Art Unit 2627
Serial No.: 10/816,158

Reply to Office Action of: 10/03/2006
Attorney Docket No.: K35R1875

AMENDMENTS TO THE DRAWINGS

ANNOTATED SHEET SHOWING CHANGES

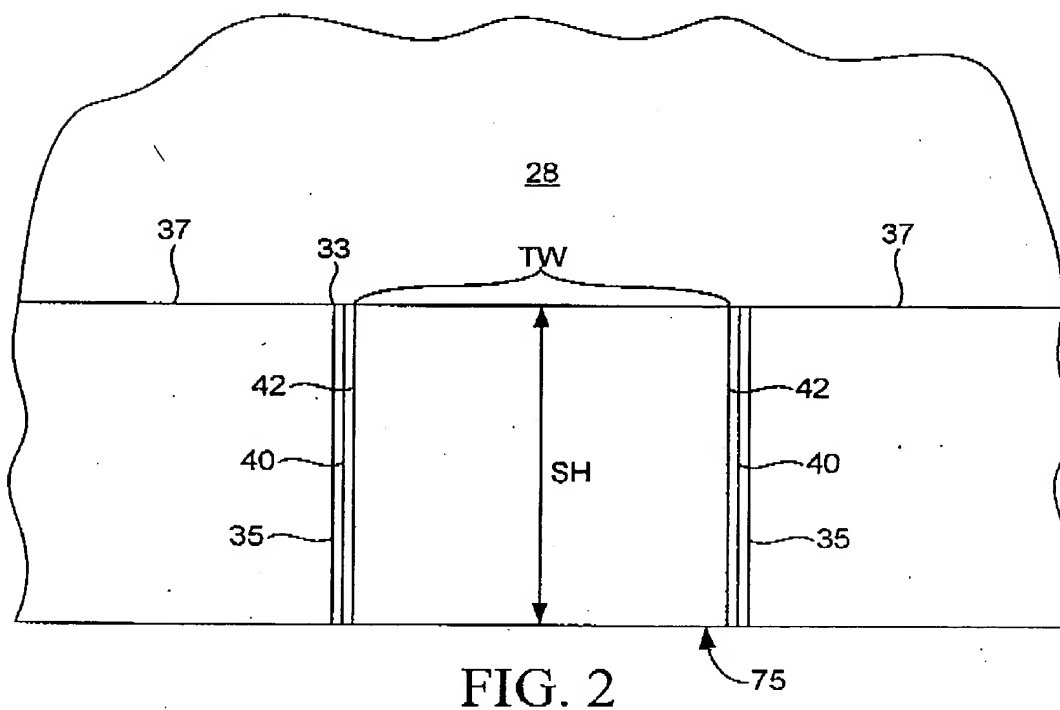
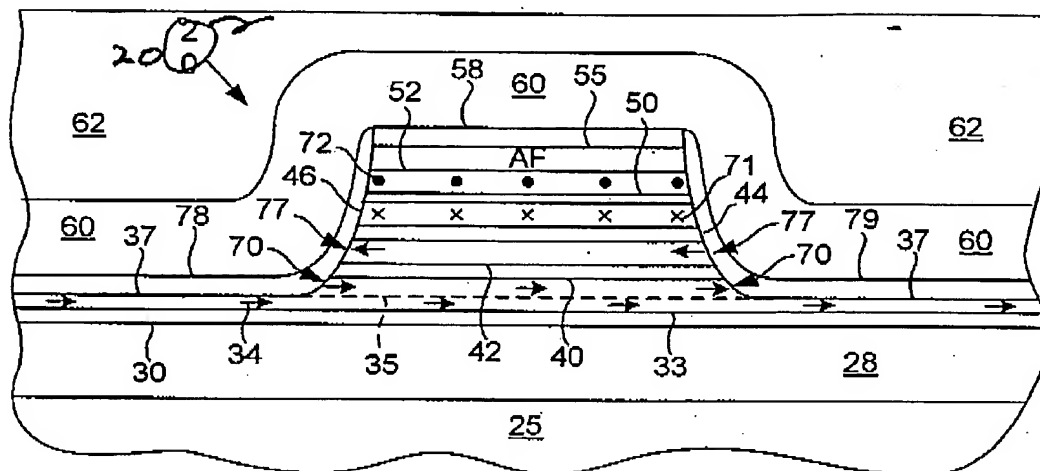
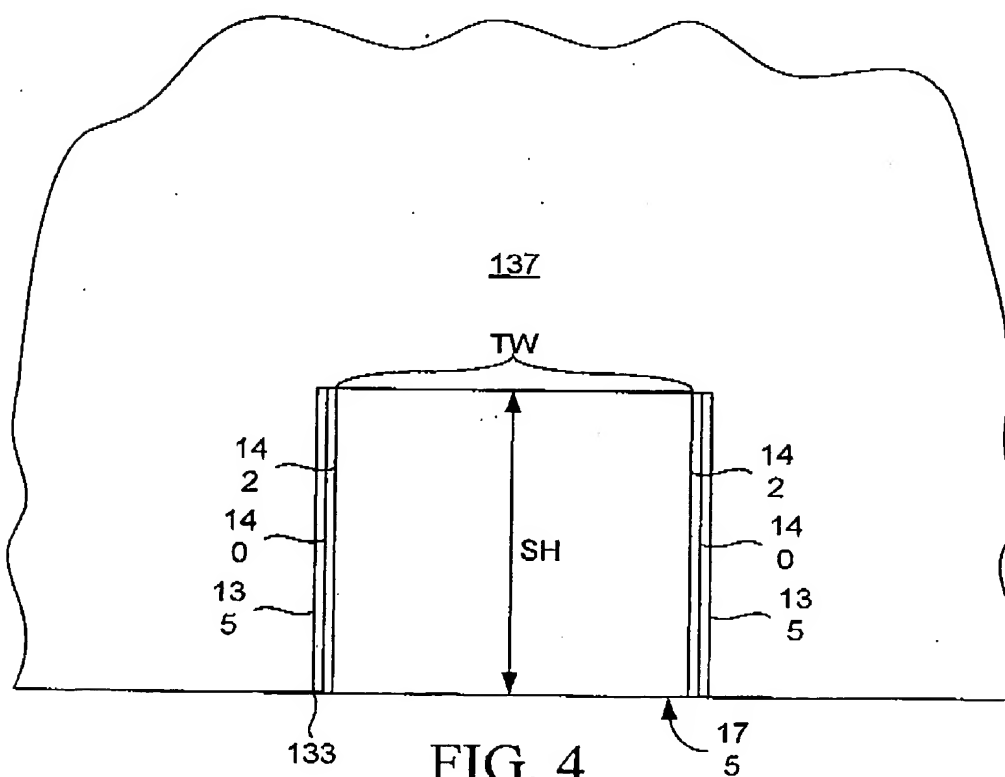
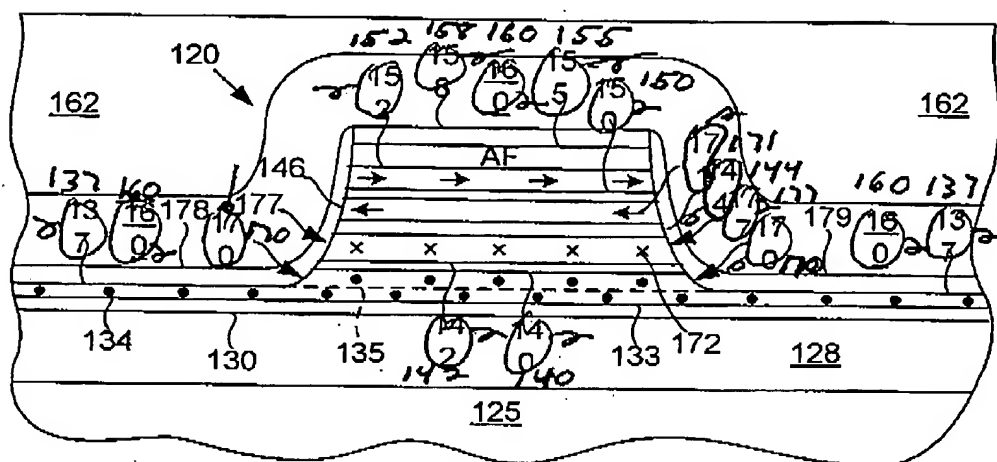
The attached sheets of drawings include changes to Figs. 1-5 and 7-10 and a new Fig. 11. Fig. 11 illustrates a feature of second layer 355 of the ferromagnetic pinning structure 350 that was claimed in Claim 11 and described in the specification at paragraph [0050] of the specification as originally filed. The remaining changes, shown in corresponding annotated sheets, make corrections to the reference numerals. Reference numerals extending over multiple lines of text have been amended to lie on the same horizontal line. Reference numerals not used to refer to the corresponding to the elements described in the text have been corrected either by correcting the numeral or repositioning the line connecting the reference numeral to the associated element. Lastly, reference numerals not used in the description as amended have been removed. No new matter has been added by any of these amendments.

Applicant has addressed the Examiner's objections with respect to the reference numerals as follows. The specification has been amended to include references to the drawing elements identified by reference numerals 162, 245, 251, 280, and 382. Regarding reference numerals 162, 245 and 280, the reference numerals were inadvertently omitted from the description; appropriate correction has been made. Regarding reference numeral 251, the description of the identified element, which corresponds to element 351 of Fig. 9 (see paragraph [0048] of the specification as originally filed), was inadvertently omitted. This omission has been corrected. Reference numeral 382 was also inadvertently omitted from the description in addition to being drawn to the wrong set of dots in the drawings. Both errors have been corrected. Reference numerals 290, 370, 377, and 390 were unused in the description, and they have been removed from the drawings, along with the instances of reference numerals 430 and 472 drawn to the wrong elements. The drawings have also been amended to have reference numeral 278 in Fig. 8 drawn to the correct element and to correct the inadvertent use of "178" in place of "478" in Fig. 10.

Turning to the other objections, Applicant has added new Figure 11 to illustrate the feature claimed in Claim 11 and described in the specification at paragraph [0050] as originally filed. Applicant has amended the title of the application to be "FERROMAGNETIC STRUCTURE INCLUDING A FIRST SECTION SEPARATED FROM A FERROMAGNETIC LAYER BY AN ELECTRICALLY CONDUCTIVE NONMAGNETIC SPACER AND A SECOND SECTION ELONGATED RELATIVE TO THE FIRST SECTION IN AT LEAST ONE DIMENSION." Applicant respectfully submits that this title is adequately descriptive of the invention as claimed. Applicant has also corrected the typographical error in paragraph [0041]. Applicant respectfully submits that the Examiner's objections to the specification and drawings have now been fully
